Comments on Holland Board of Public Works Power Supply Study

David A. Schlissel

April 30, 2010

Schlissel Technical Consulting, Inc., has completed a review of Holland Board of Public Works' ("HBPW") new Power Supply Study ("the Study").

Figure 2: Modified Figure 8-1 from Study Including Projected CO₂ Emission Levels HBPW Would Need to Achieve to be Consistent with the National Caps in the Waxman-Markey Legislation

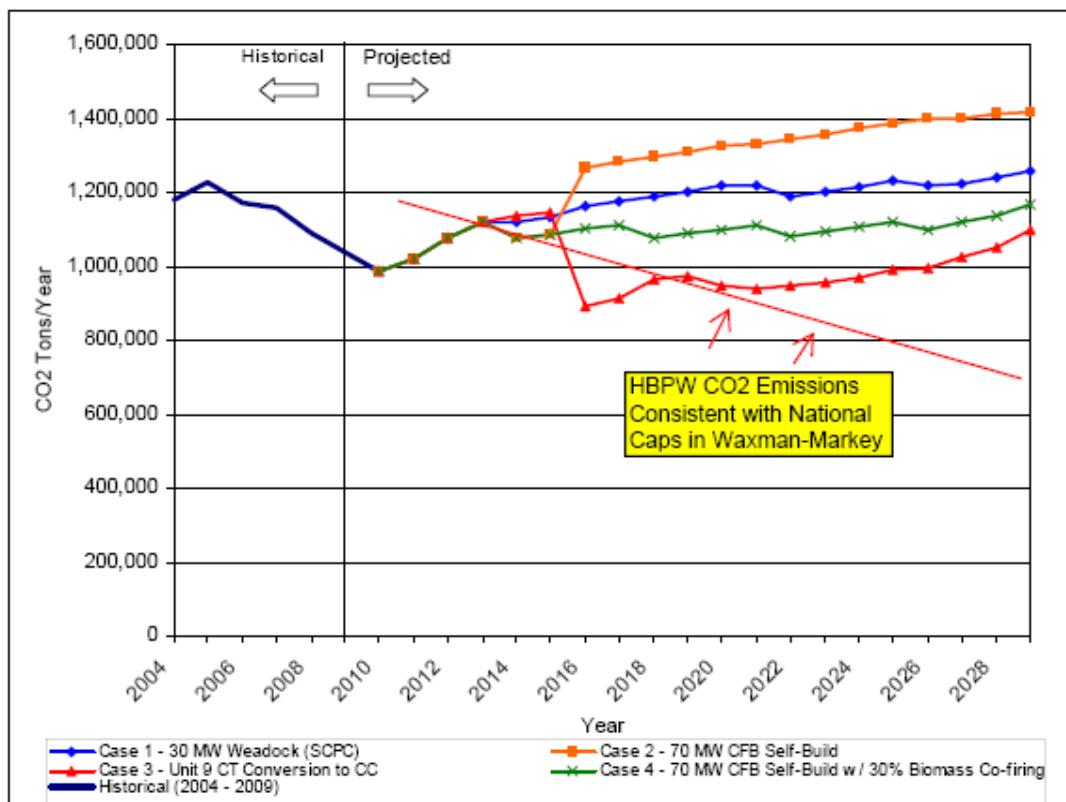
Even with 30 percent biomass co-firing at a new CFB coal plant, HBPW's annual CO₂ emissions would *increase* by 8 percent between 2010 and 2030. Of the four scenarios whose annual CO₂ emissions are presented in Figure 8-1 in the Study, Case 3, with the conversion of the Unit 9 CT to a combined cycle unit, would have the lowest annual CO₂ emissions – yet even the CO₂ emissions in this scenario would increase slightly between 2010 and 2030.

The CO₂ emissions profiles presented in Figure 8-1 from the Study are reproduced in Figure 2 below with a line added for the projected annual CO₂ emissions that HBPW might be limited to in order to be consistent with the national CO₂ caps in the Waxman-Markey legislation that was approved by the U.S. House of Representatives.

As can be seen, HBPW's own projections show that its annual CO₂ emissions would increase, perhaps significantly, in each of the three scenarios in which it would self-build or participate in the ownership of a new coal plant. These increased CO₂ emissions would happen at the very time that legislation under consideration in Congress would be mandating reductions in emissions. In other words, HBPW's CO₂ emissions would be going in the wrong direction, i.e., up, at a time when the mandated levels of emissions were going down.

Figure 3: Black & Veatch vs. Synapse CO₂ Price Forecasts

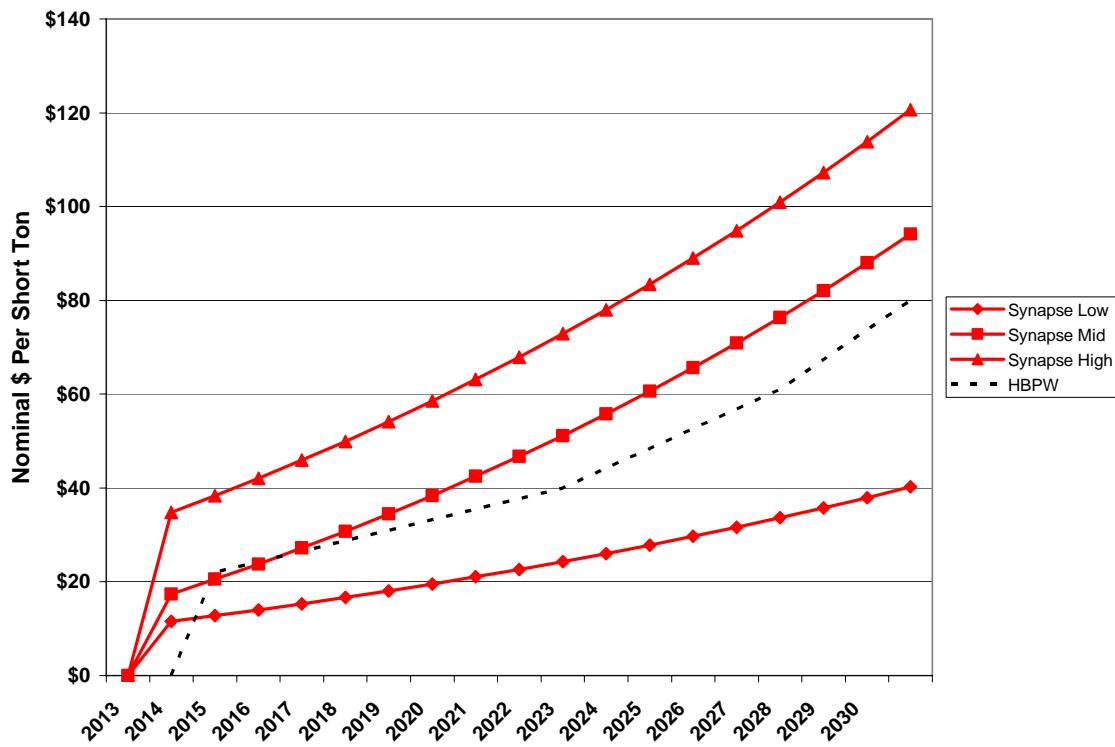
Figure 3, below, compares the single CO₂ price trajectory used by Black & Veatch in its modeling analyses with the CO₂ price projections developed by Synapse Energy Economics.⁹

As can be seen in Figure 3, the single Black & Veatch CO₂ and the Synapse Mid CO₂ price trajectories are not too different although the Black & Veatch CO₂ prices are below the prices in the Synapse Mid CO₂ trajectory in most years. However, the range of CO₂ prices encompassed by the Synapse Low and High CO₂ price trajectories allow for uncertainty whereas the single Black & Veatch CO₂ price trajectory does not.

Figure 4: Levelized Black & Veatch and Synapse 2008 CO₂ Prices Compared to Results of Modeling of Proposed Federal Legislation

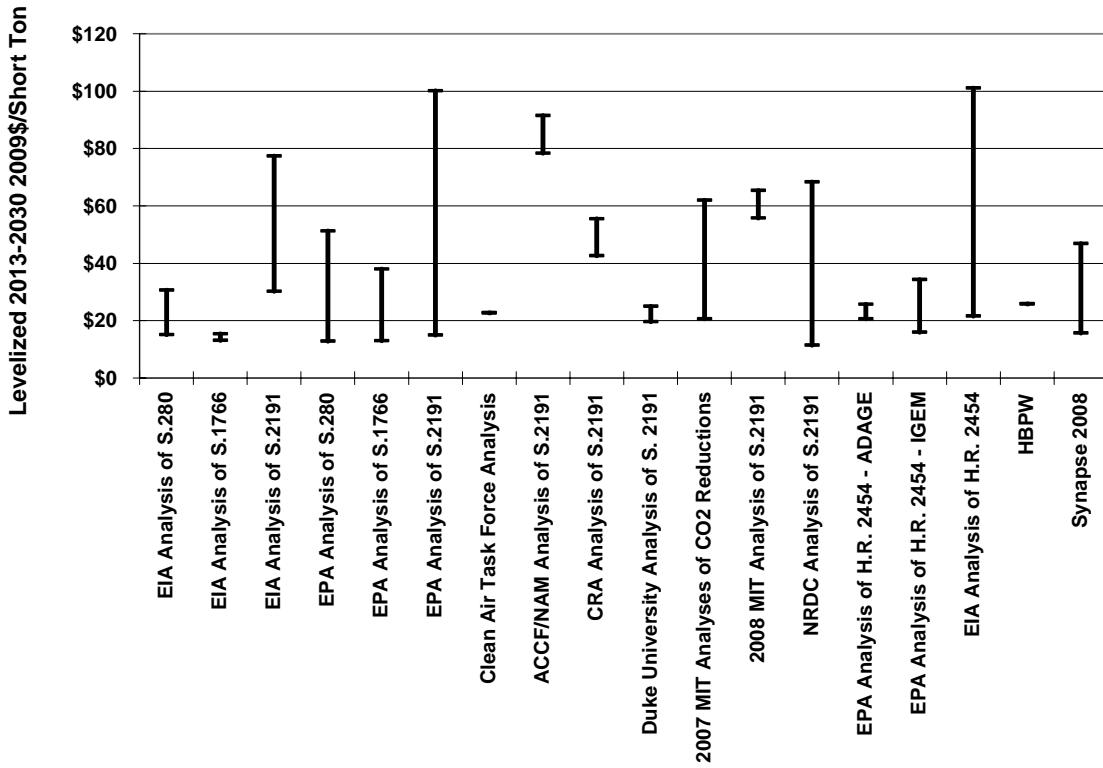
Figure 4 confirms that the single CO₂ price trajectory used by Black & Veatch did not adequately allow for the potential uncertainties associated with the design and stringency of future federal regulation of greenhouse gas emissions and for the possibility that CO₂ prices could be substantially higher than Black & Veatch now assumes.

It should be noted that the third through fifth bars from the right in Figure 4 show the ranges of leveled CO₂ prices from the modeling of the Waxman-Markey bill by the EIA and the EPA. However, it is not certain that whatever bill is ultimately passed by the U.S. Congress actually will reflect the terms of that legislation. This is the reason why the results of the modeling of the other legislation that has been introduced in previous U.S. Congresses remain relevant.
